From: [Schofer, Fred](#)
To: [Algama, Don](#); [Esmaili, Hossein](#); [Helton, Donald](#); [Murphy, Andrew](#); [Nosek, Andrew](#); [Pires, Jose](#); [Compton, Keith](#); [Barto, Andrew](#); [Wagner, Brian](#); [Chang, James](#); [Armstrong, Kenneth](#); [Lee, Richard](#); [Witt, Kevin](#); [Helton, Shana](#); [Reckley, William](#); [Jones, Steve](#); [Casto, Greg](#)
Subject: Comment resolution matrix for use during today's discussion of RES comments on the Tier 3 Regulatory Analysis
Date: Tuesday, September 10, 2013 10:53:17 AM
Attachments: [Reg Analysis_rA Comment Resolution Matrix.xlsx](#)

Regulatory Analysis, Rev. A Comment Resolution Matrix

Hello all, please see the attached final documents for the June 19 11am-12pm Chairman briefing on the spent fuel pool study and regulatory analysis. Note that the briefing agenda changed slightly from OGC comments to indicate the regulatory analysis and backfit analysis discussions are focused on the reference plant.

Figure 4 Comparison of annual PGA exceedance frequencies for U.S. Mark I reactors (USGS 2008 model) (rock hazard curves)

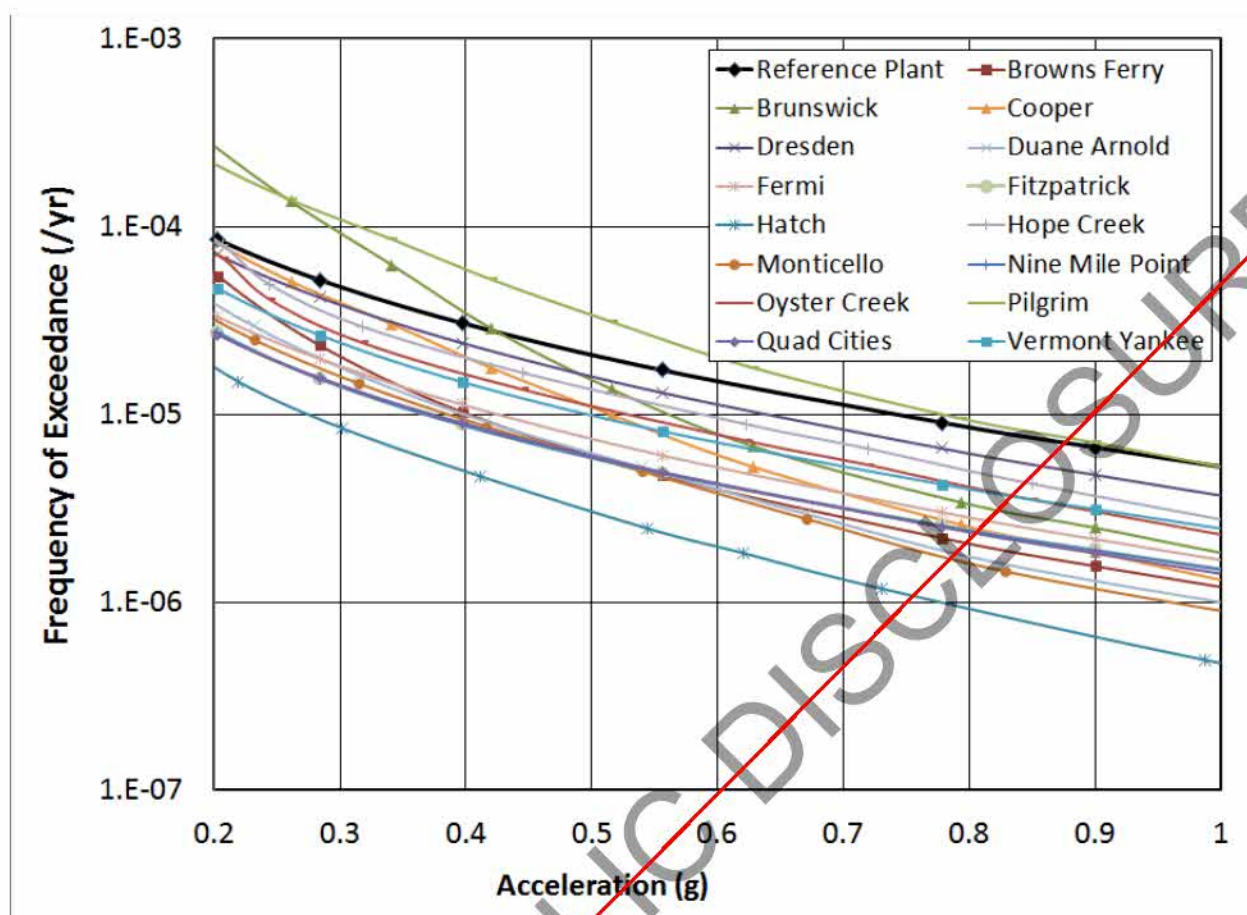
383	NRO	03.29.13	Pg31	Theresa Clark	Section 3.1 (page 31, Figures 4 and 5) should indicate in the figure captions that these are hard rock hazard curves	Jose P.	Response: The captions have been modified to address the comment.		Closed	DivDir Concurrence	--
384	NRO	03.29.13	Pg33	Theresa Clark	Section 3.2 (page 33, last paragraph) includes this statement: "In addition to the PGA, ground motions at a site are also characterized by their frequency content expressed in terms of response spectra. Based on the USGS 2008 model, a uniform hazard site Ground Motion Response Spectrum (GMRS) (NRC, 2007b) was derived for the GI-199 study and used in this study." It is incorrect to combine the term uniform hazard response spectra with the term GMRS. In addition, Footnote 5 states that "the term GMRS has a specific meaning in the context of Regulatory Guide (RG) 1.208 (NRC, 2007b). In this report, the term GMRS is used more generally." The report should describe how the response spectrum for the selected site was developed. If it is not consistent with the definition of the GMRS in RG 1.208, then use a different name. Clarify whether the response spectrum for the reference site shown in Figure 7 is a uniform hazard response spectrum. In addition, do a global search for "GMRS" because it is used throughout the report.	Jose P.	<p>Response: The footnote has been deleted. After further examination, it was confirmed that the GMRS in the report is based on the guidance in Regulatory Guide 1.208 used in conjunction with USGS (2008) model. This is clearly noted in the report and repeated often. Use of a different hazard model and maybe a more detailed analysis might produce a somewhat different GMRS. We do not think that the footnote is needed because the assumptions are clearly indicated. Also, as per the response to the comment related to the use of the USGS (2008) model (comment 379) we prefer not to make references to licensing review aspects in a study of this type.</p> <p>Nevertheless, when referring to the GMRS, the text in the report will be modified to replace "site GMRS" with "reference GMRS." Also, the text at the end of Section 3.2 and after Table 5 will be modified to read:</p> <p>In addition to the PGA, ground motions at a site are also characterized</p>		Closed	DivDir Concurrence	--

892	OGC	05.23.13	37	Tison Campbell	Figure 4 Comparison of annual PGA exceedance frequencies for U.S. Suggest updating the figure to identify the reference site as a reminder to readers	Jose P.	Figure was updated and the legend now says "Reference Plant" instead of Peach Bottom.		Closed	OD Concurrence	
893	OGC	05.23.13	37	Tison Campbell	Figure 5 Comparison of annual exceedance frequencies for 1 Hz spectral accelerations for U.S. Mark I reactors (USGS 2008 model) (rock hazard curves) Suggest updating the figure to identify the reference site to readers	Jose P.	Figure was updated and the legend now says "Reference Plant" instead of Peach Bottom.		Closed	OD Concurrence	
894	OGC	05.23.13	39	Tison Campbell	bin 3, with initiating annual frequencies on the order of 1×10^{-5} to 2×10^{-5} , have the potential of challenging the structural integrity Why not just say "could challenge"?	Jose P.	Suggested edits made.		Closed	OD Concurrence
